ADDENDUM NO. 2

DATE: November 22, 2013

Contract 14-C-00006; Lake Eckles Pump Station and Force Main Replacement

W.O. 510H
SHEET
C-2
OF 53

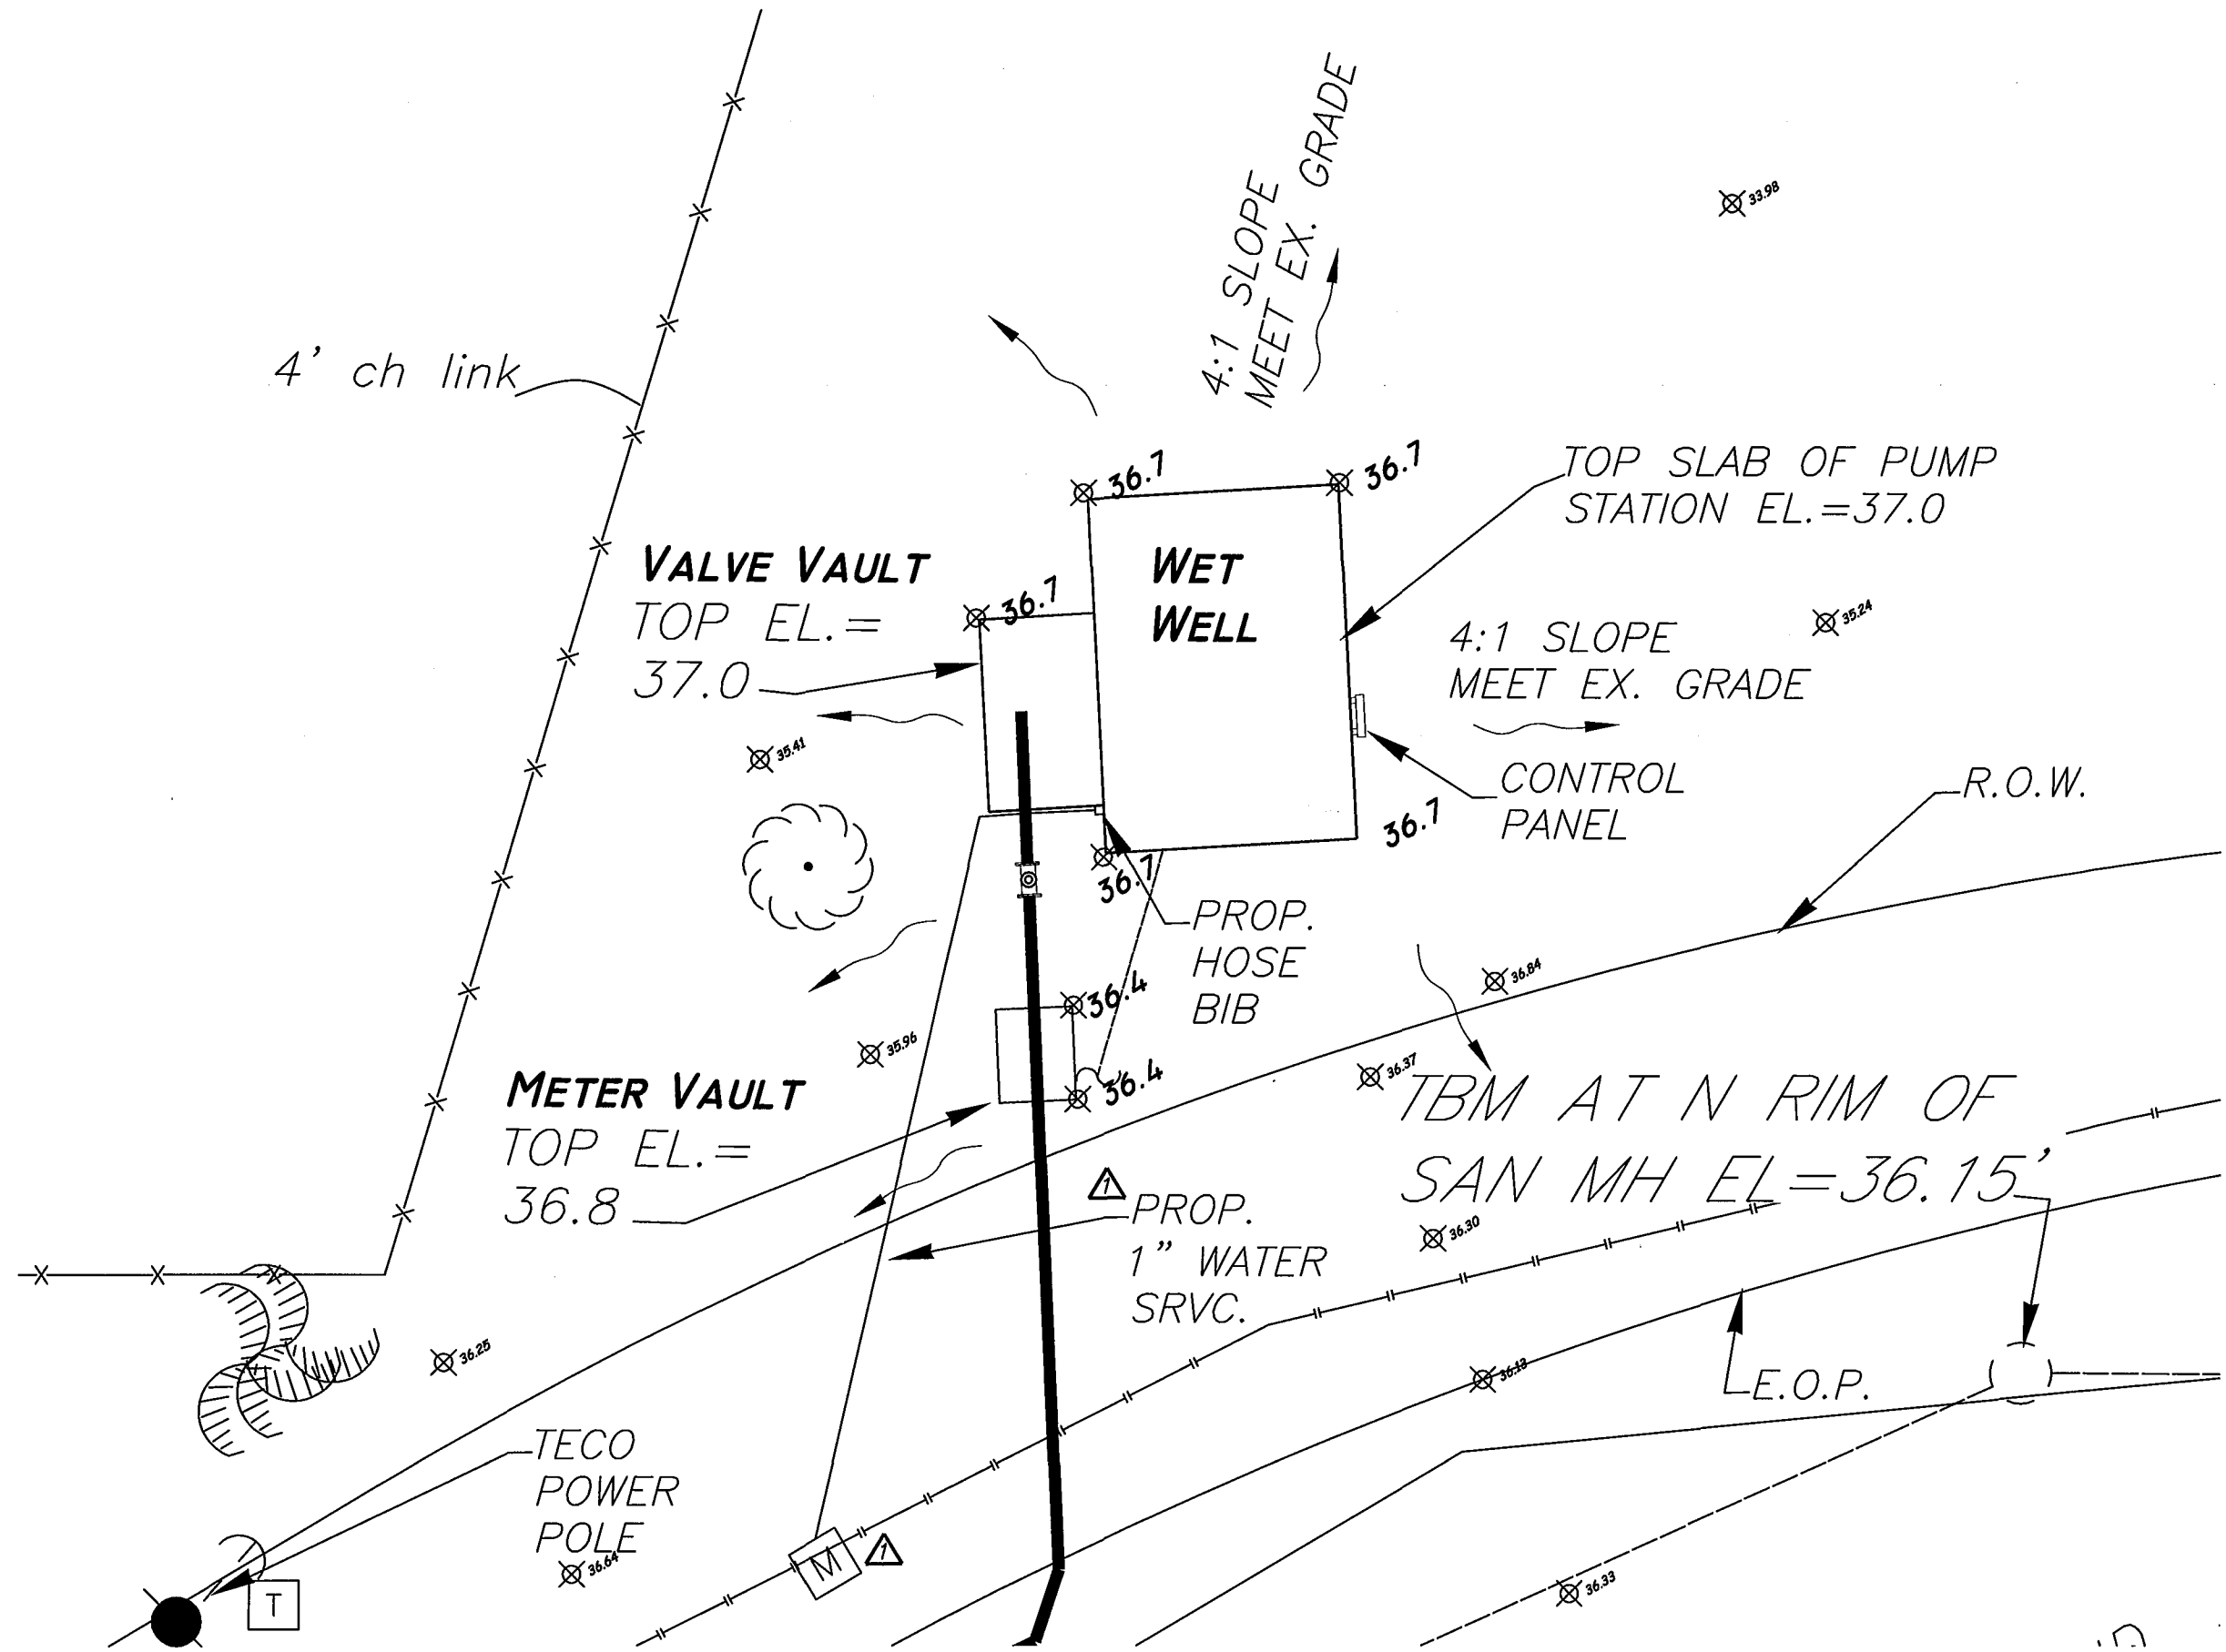
No.	DATE	REVISIONS	No.	DATE	REVISIONS
3			6		
2			5		
1	11/12/13	ADDED NEW WATER METER & 1" SERVICE LINE	4

5 RAIN GAUGE DETAILS

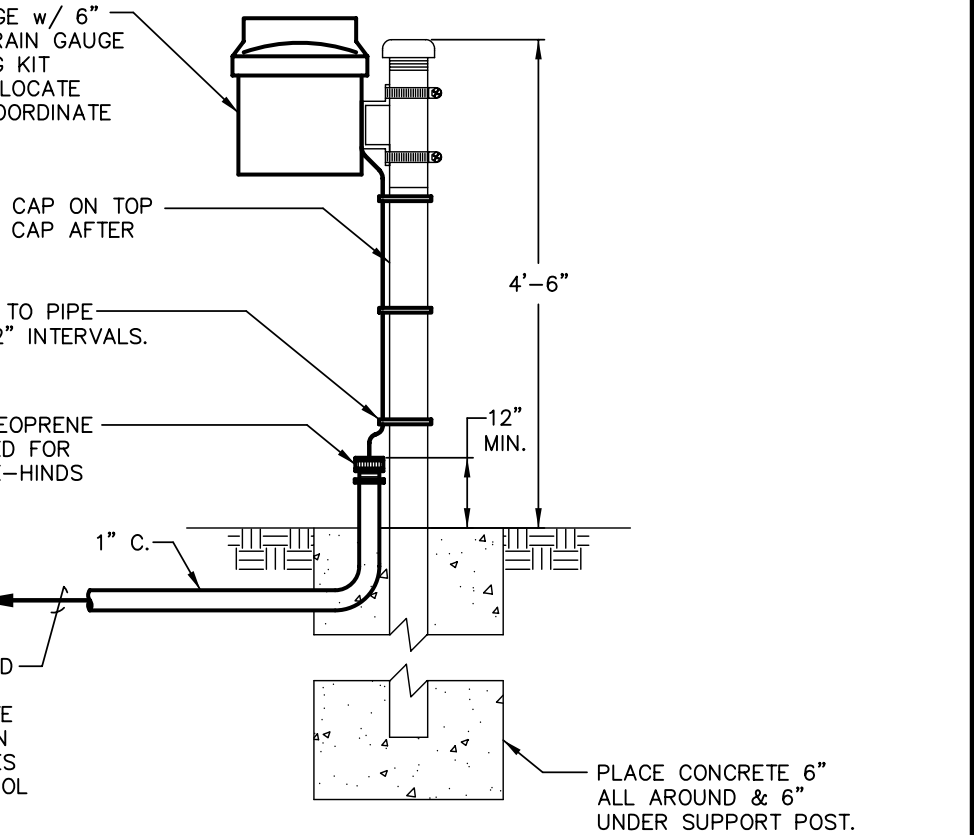
- Item 7: Add, on page C-11 of the Specifications, to Contract Item 6940-10, in the second paragraph, after "station," the following: rain gauge and associated wiring, mounting and instrumentation,

CAMPBELL SCIENTIFIC MODEL TE525 RAIN GAUGE w/ 6" ORIFICE AND SCALED PULSE OUTPUT. MOUNT RAIN GAUGE TO PIPE USING CAMPBELL SCIENTIFIC MOUNTING KIT AND FOLLOW MANUFACTURER'S INSTRUCTIONS. LOCATE RAIN GAUGE AS SHOWN ON THE SITE PLAN. COORDINATE FINAL LOCATION WITH OWNER.

6' LONG 1 1/2" DIA. SCHEDULE 80 PIPE. WELD CAP ON TOP OF PIPE & HOT DIP GALVANIZE ENTIRE PIPE & CAP AFTER FABRICATION.

SECURE RAIN GAUGE CABLE TO PIPE WITH BLACK TY-RAPS AT 12" INTERVALS. USE T & B TY29MX. (TYP.)

CORD/CABLE FITTING c/w NEOPRENE BUSHING & GLAND NUT SIZED FOR RAIN GAUGE CABLE. CROUSE-HINDS CGB SERIES. (TYP.)

RAIN GAUGE CABLE PROVIDED BY RAIN GAUGE SUPPLIER, ROUTED IN 1" C. COORDINATE LENGTH OF CABLE WITH RAIN GAUGE SUPPLIER. NO SPLICES IN CABLE LENGTH TO CONTROL PANEL WILL BE PERMITTED.

W.O. 510H
SHEET
C-15
OF 53

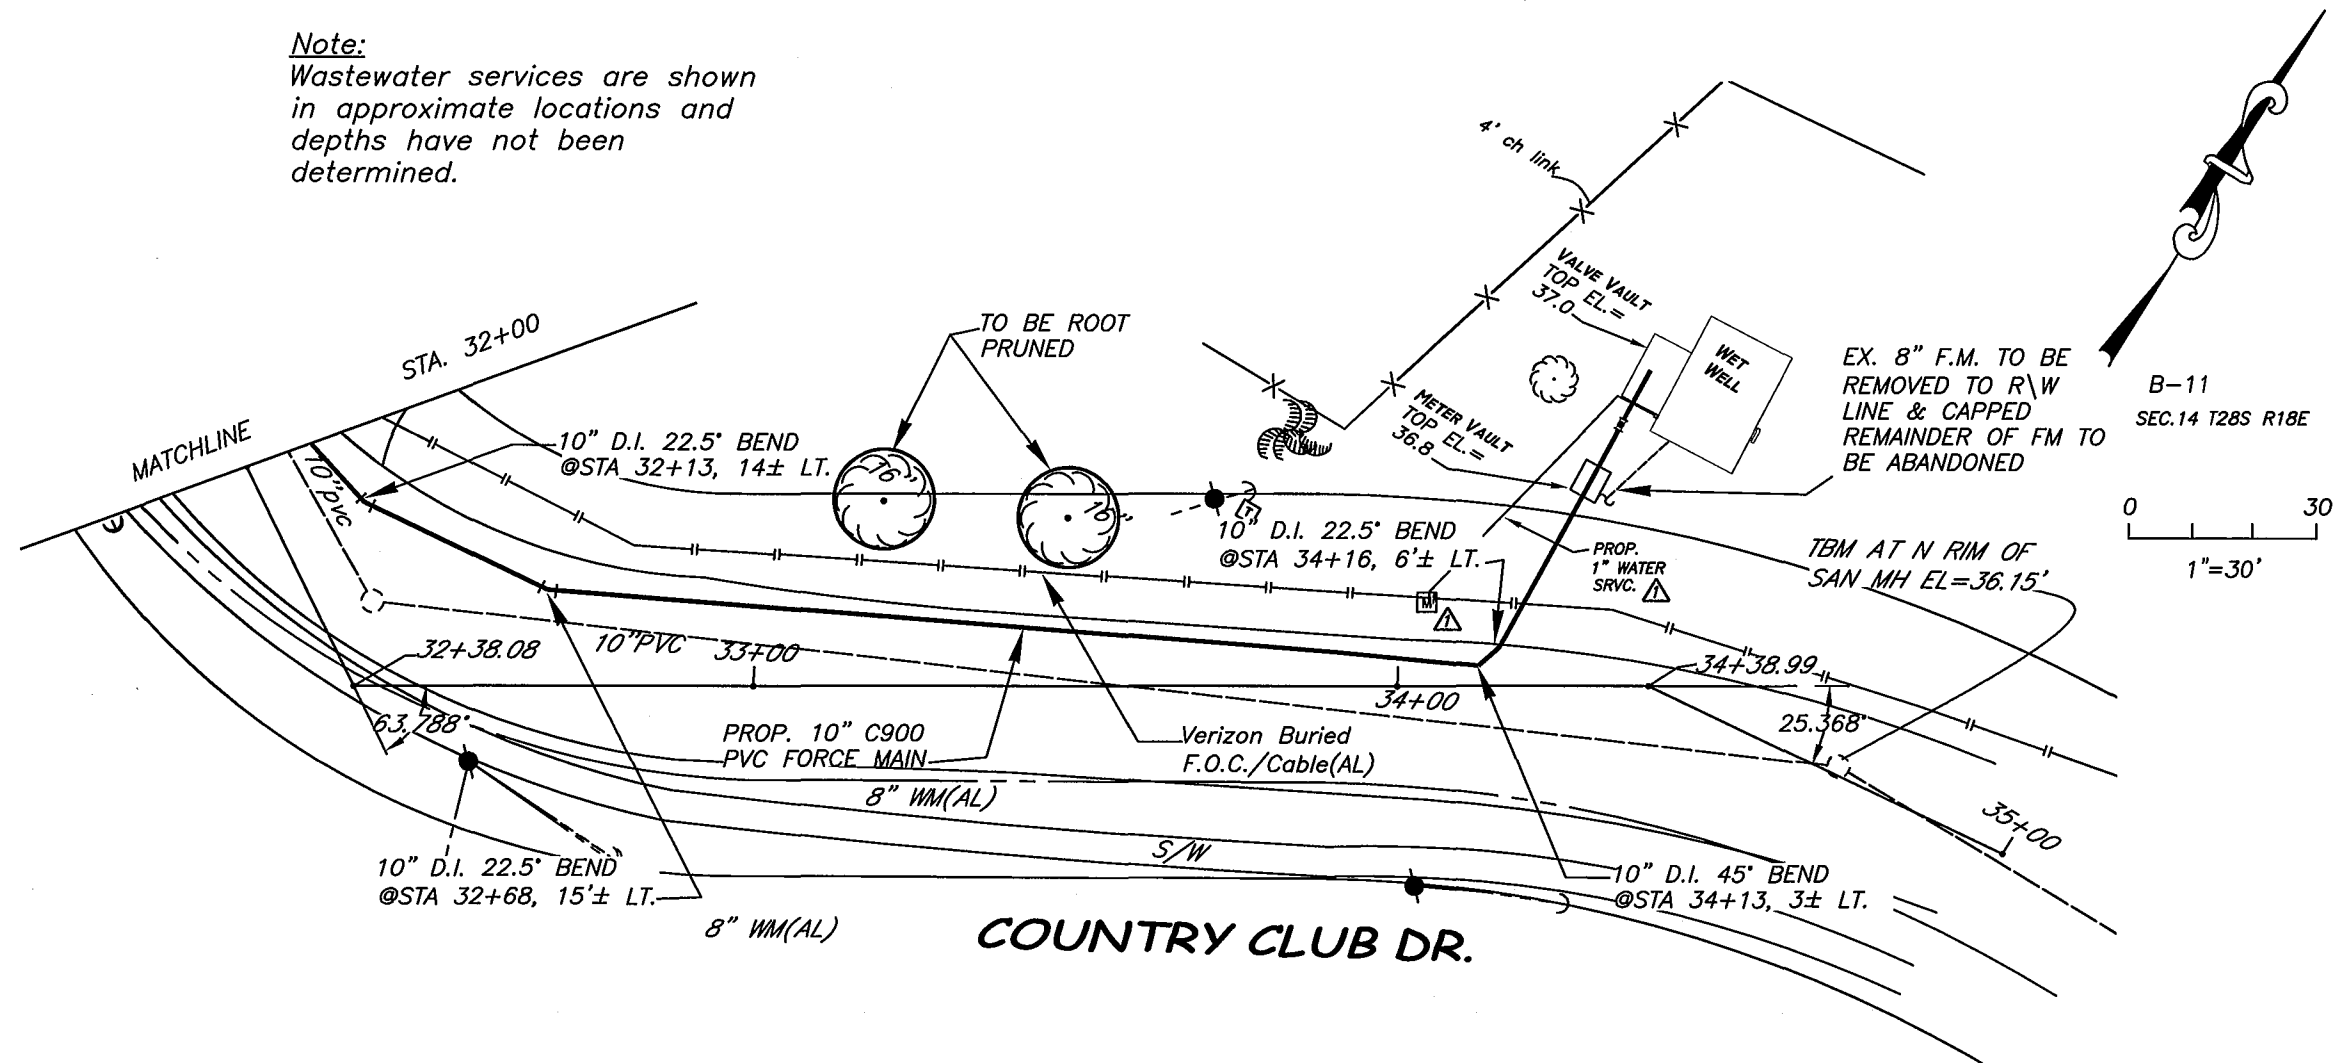
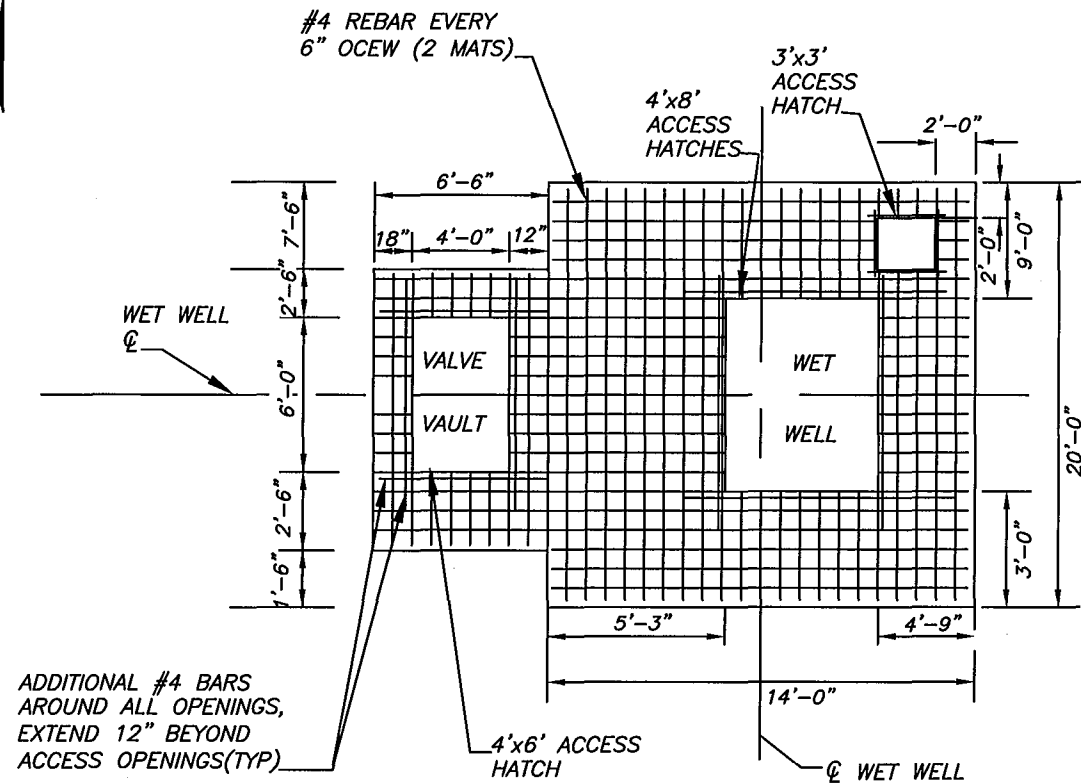
No.	DATE	REVISIONS	No.	DATE	REVISIONS
3			6		
2			5		
1	11/12/13	ADDED NEW WATER METER & 1" SERVICE LINE	4

BAFFLE WALL/FLOOR DETAIL

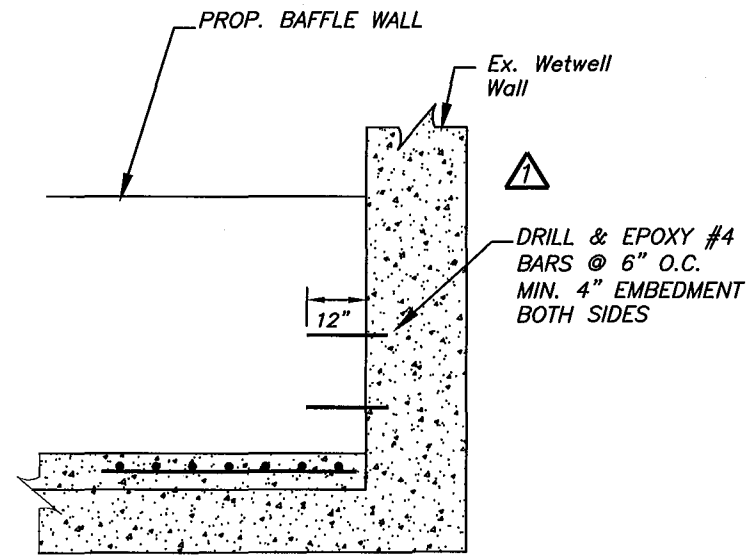
No.	DATE	REVISIONS	No.	DATE	REVISIONS
3			6		
2			5		
1	11/12/13	ADDED NEW BAFFLE WALL DETAIL	4
